# Washington State Convention Center Addition Project: Co-Development

Design Review Board Recommendation Meeting 01  
05-17-2016

**2 EDG 03 COMMENT  
SUMMARY**

**3 EDG 03 COMMENT  
RESPONSES**

ENLARGED ELEVATION AT HOWELL ST.

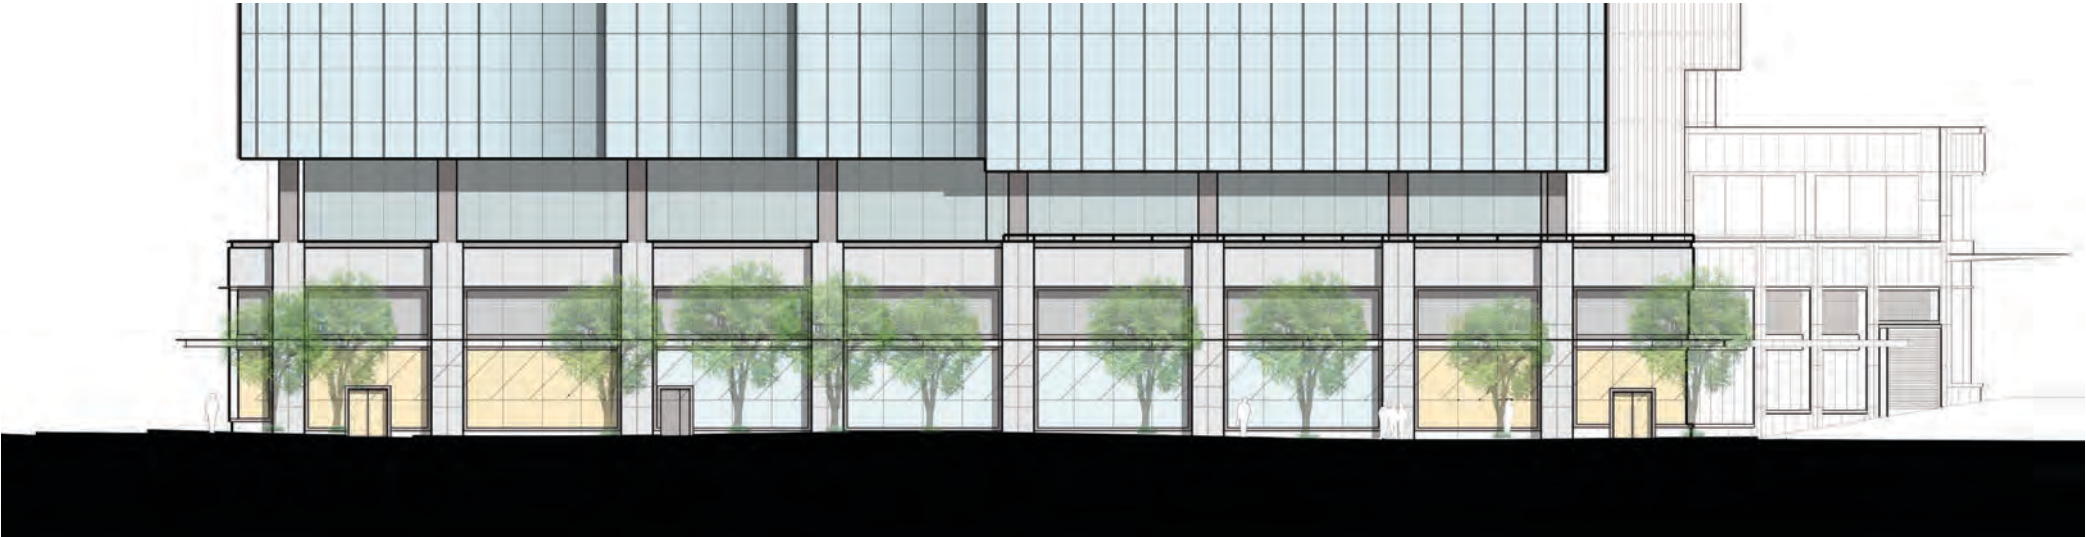
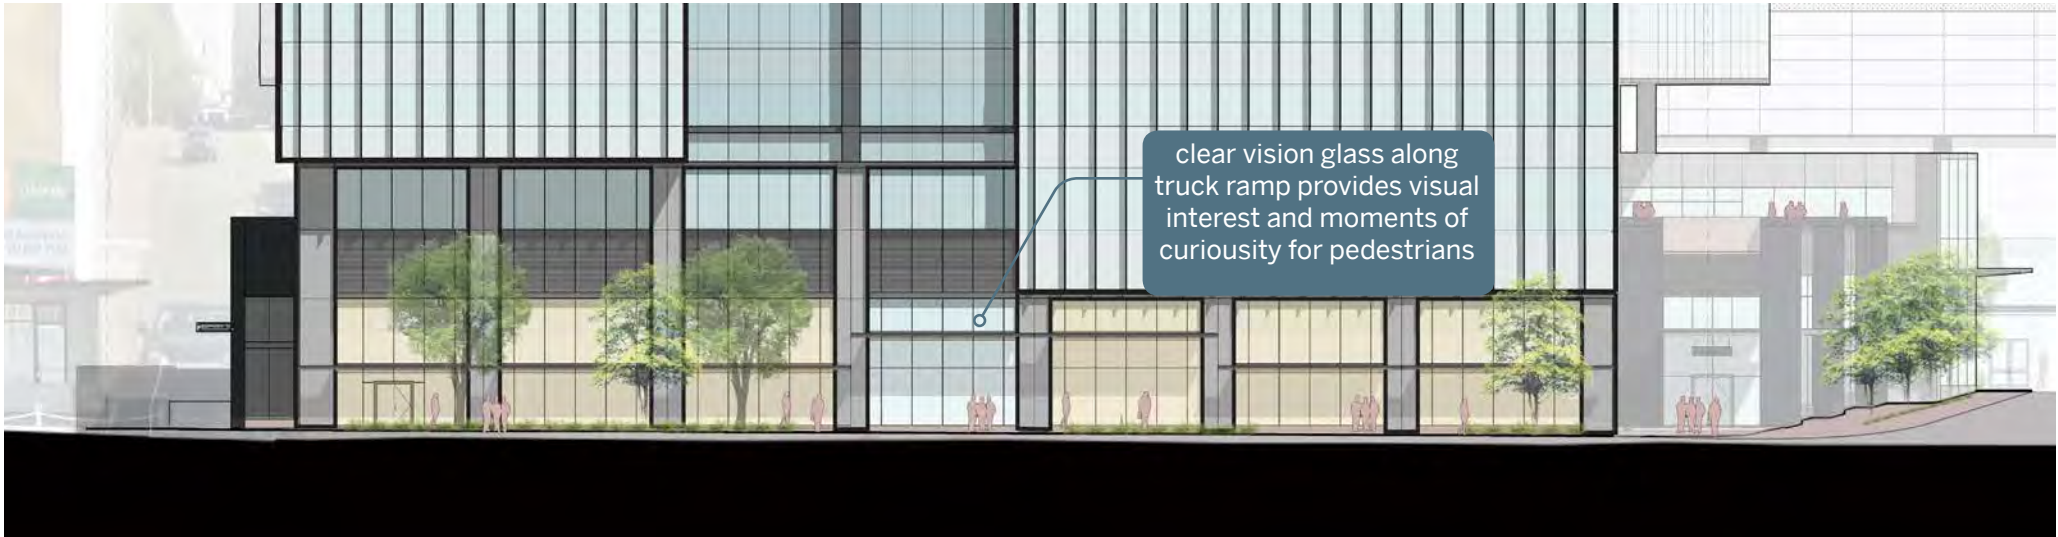
**COMMENT 11F - HOWELL STREET**  
At the EDG#3, the Board re-affirmed that the screening of the truck ramp in the middle of bock C (pg 59), and any perimeter back-of-house on either block (pg 60), should be a sophisticated glass design, providing an excellent pedestrian experience and interest by using varying patterns or materials.

**RESPONSE** - The glass at the truck ramp along Howell Street is proposed to be a clear vision glass to match the adjacent storefront to visually integrate into the architectural language of the building and provides continuity for pedestrians at the street level. This area has been minimized significantly from EDG 03 to provide more street level use at the sidewalk. The activity of the trucks moving down the ramp provides visual interest and moments of curiosity for pedestrians.

ELEVATION AT HOWELL ST.

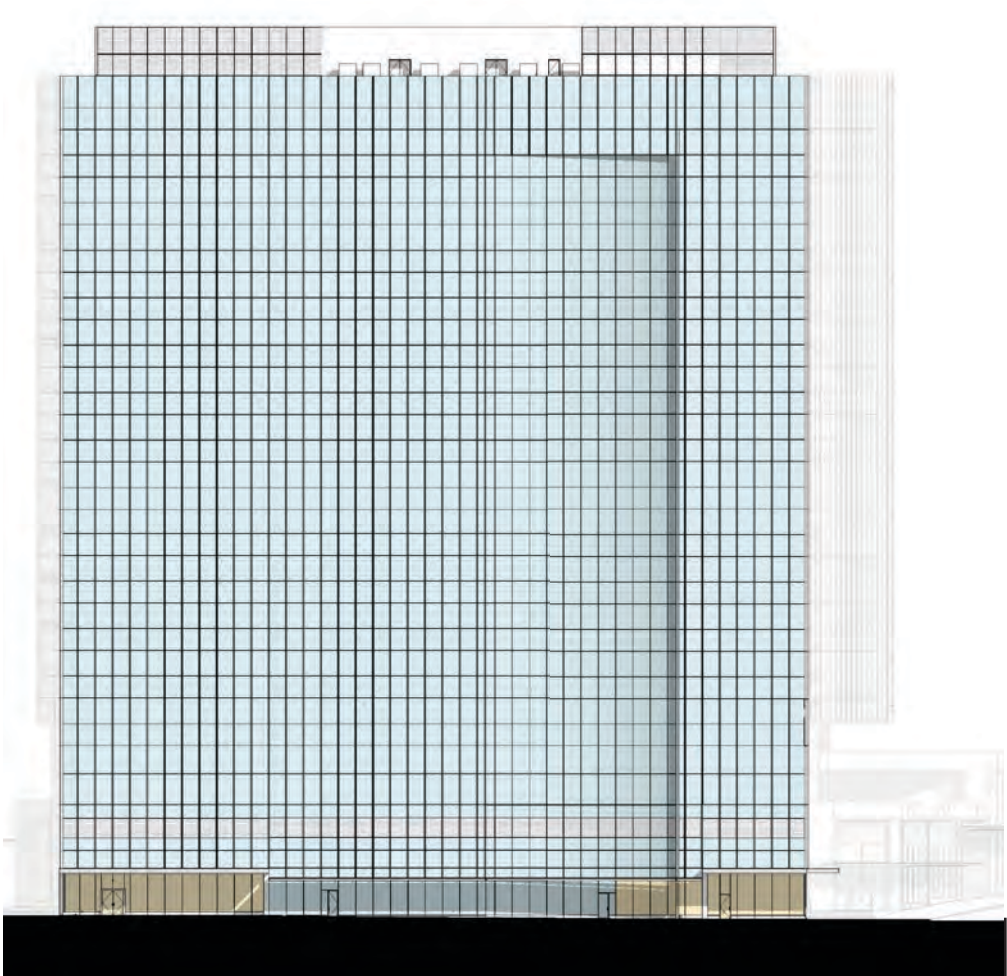
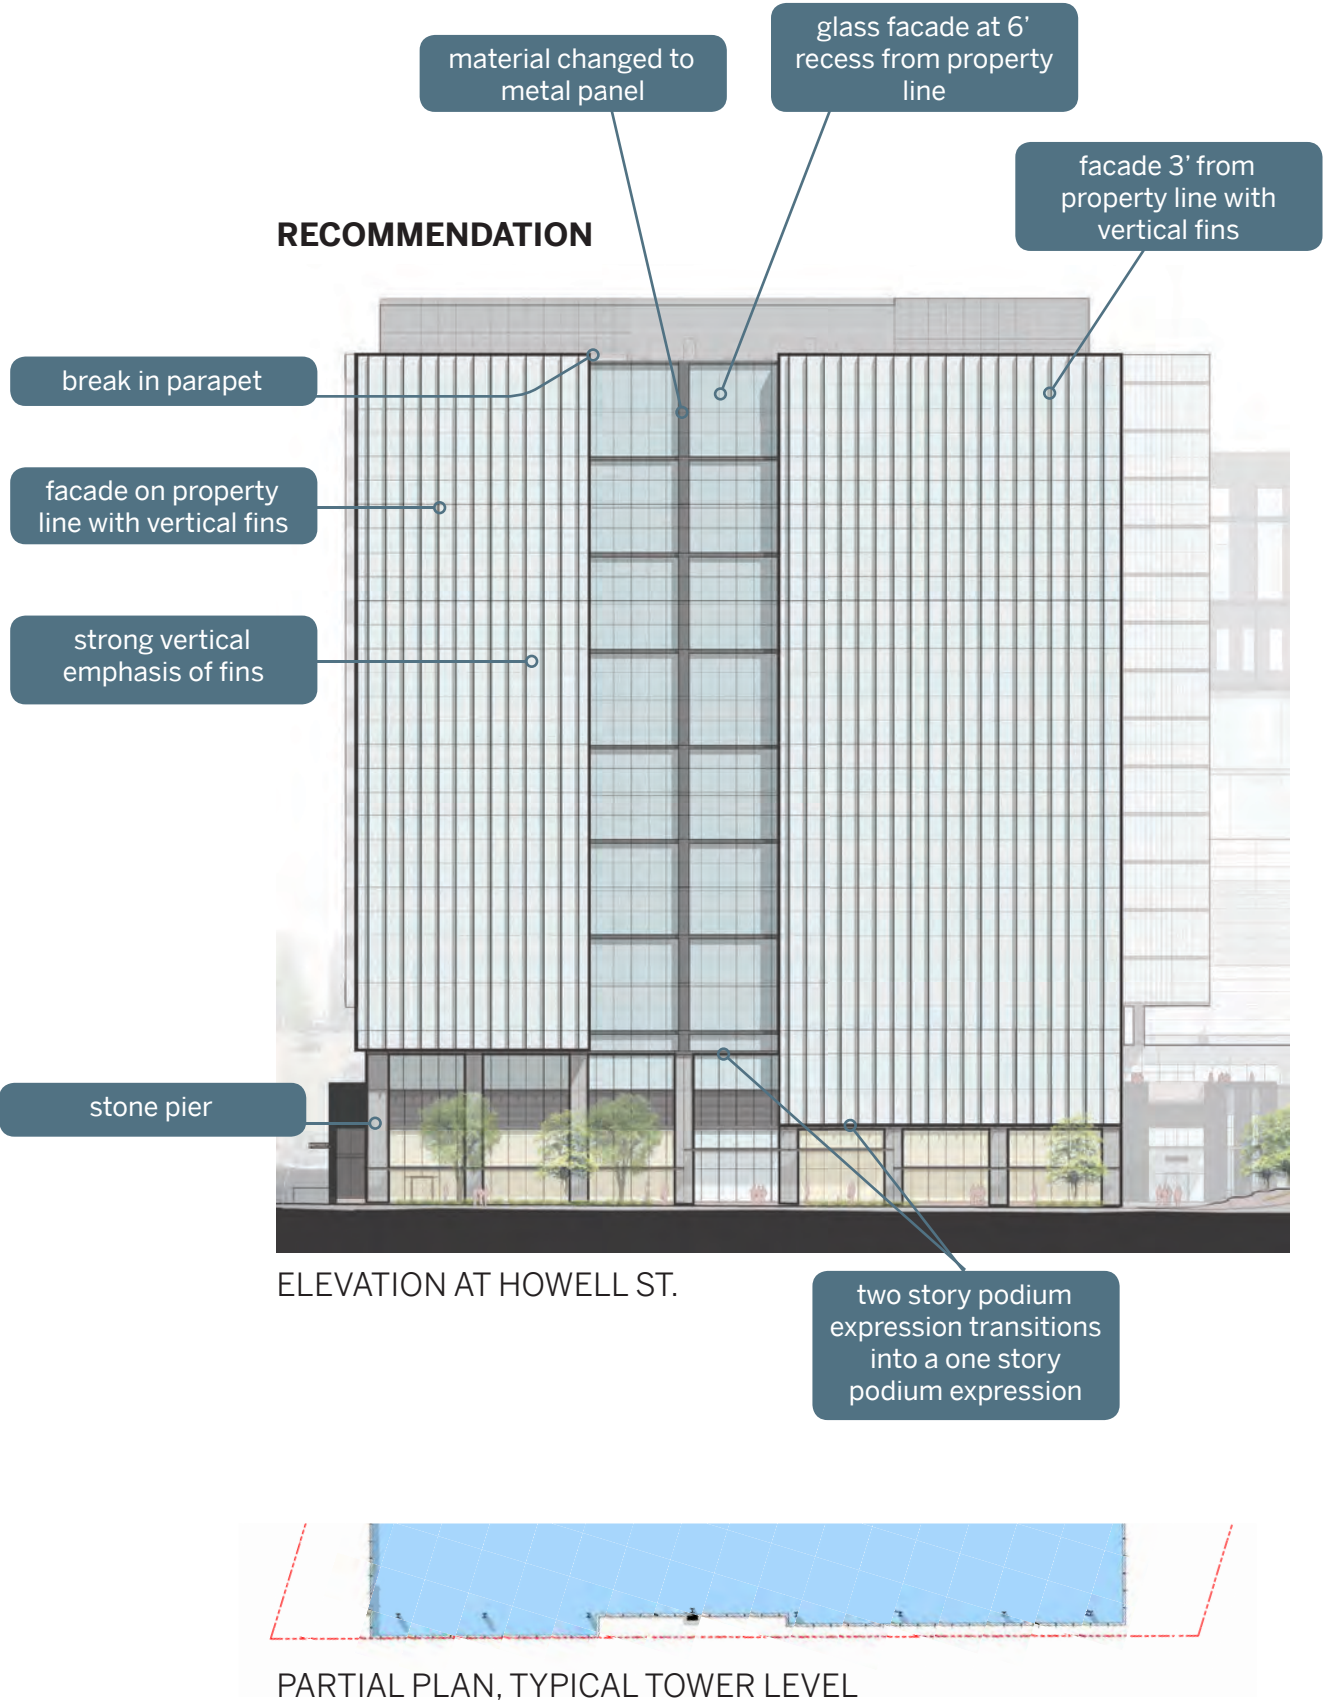
**MUP 01** - The Howell tower facade runs straight down to grade, uninterrupted. Per guidance, redesign to add a legible podium, preferably 2-3 stories in proportion to the 240 ft tall mass above, and with a substantial 'gasket' or setback at the transition.

**MUP 01** - The approx. 2 ft deep divot with canted wall plane proposed is barely perceptible on the 120x 240 ft flat Howell wall (which is NW facing and will not benefit from much shadow-play); this is contrary to the explicit DRB guidance under Departure #3/pg 41 "one larger & deeper (than 3 ft) recess" and the recess "should extend to the parapet" to make a legible break at the roof edge. This departure/modulation proposal is going backwards from DRB guidance and is not sufficient on such a large, undifferentiated plane; Redesign with a substantially deeper, legible recess to at least partially comply with Code.

**MUP 02** - The revised, singular and wider recess as shown on g106 is an improvement, however the cladding inside the recess is identical to the adjacent walls; revise to provide some contrast and improve legibility of this modulation. also, the 6 ft depth is less than half the 15 ft code requirement; the DRB will evaluate.

**RESPONSE** - The Howell Street facade has been updated with a stronger two story podium expression with a transition to a one story expression to bring more variety to the facade closer to the street level. A larger single 6 feet recess is being proposed above the podium expression to break the length of the facade. The facade east of the recess is located at the property line while the facade west of the recess is 3 feet back from the property line. The facade is broken into three pieces on three different planes and breaks the facade down so that the proportions closely replicate the scale of the buildings across Howell St. A vertical expression is created by providing a 4" fin at every mullion, except at the recessed facade where the glass will be neutral.
